Technical Memorandum

SUBJECT: IR-25-01 (Pine Creek Ranch)

Figure 1 - Project Location

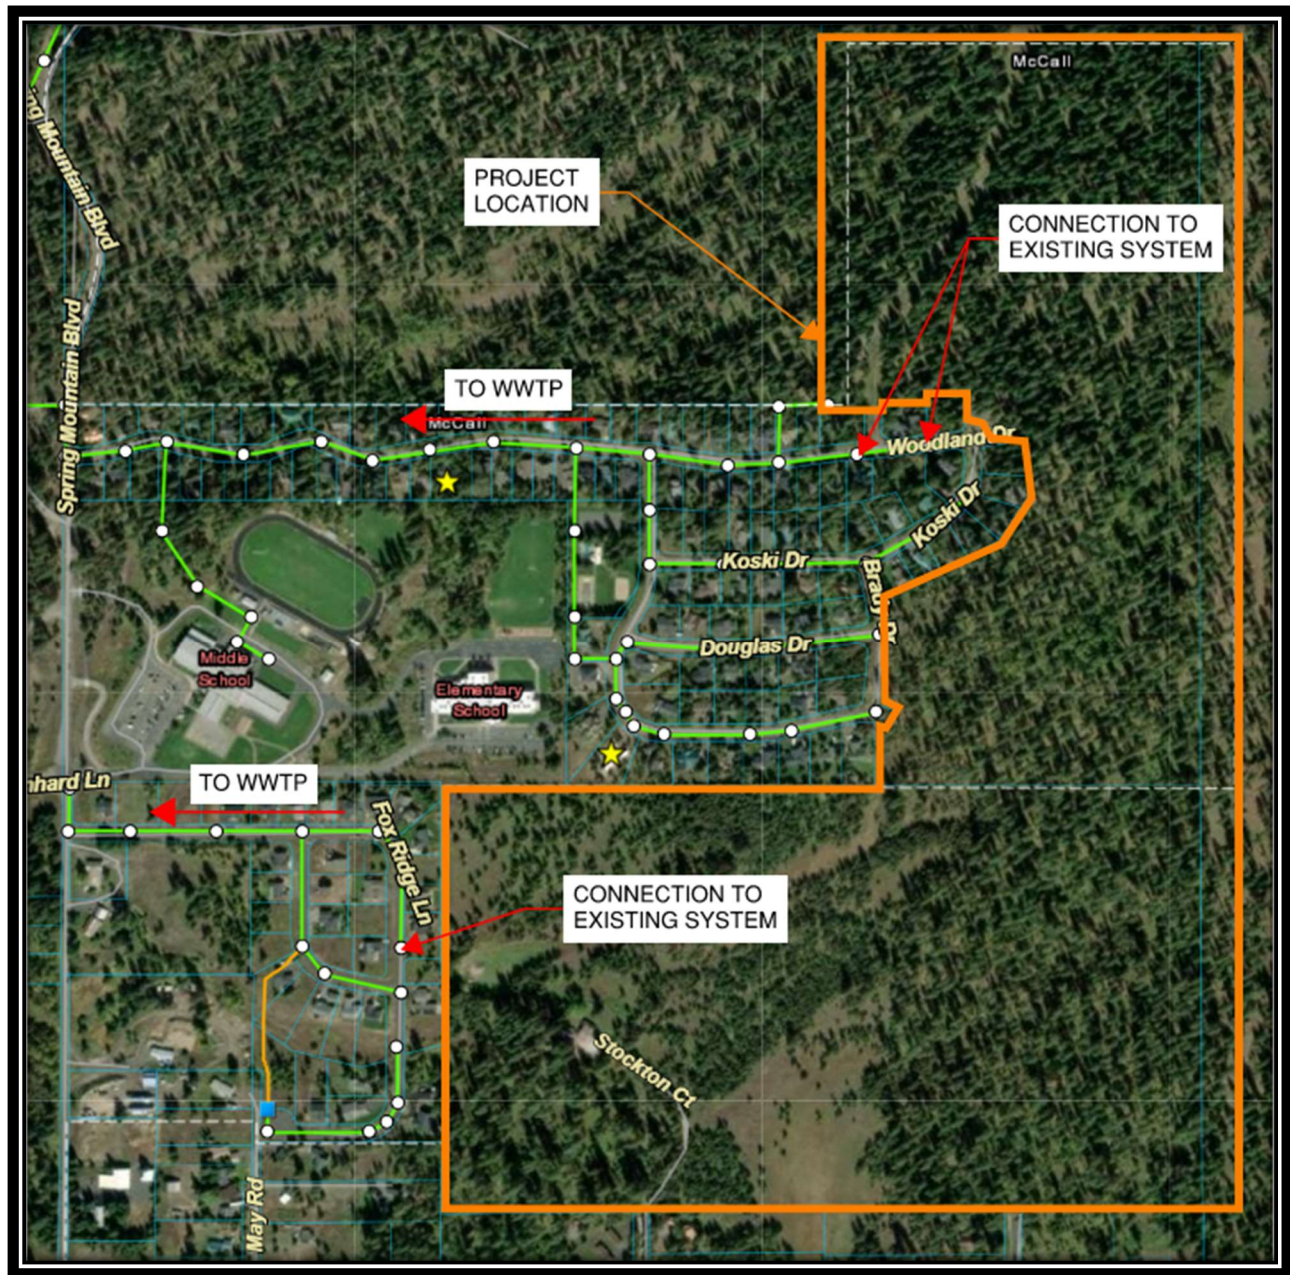
The proposed development project location is shown on **Figure 1** with flow direction shown by the red arrow.
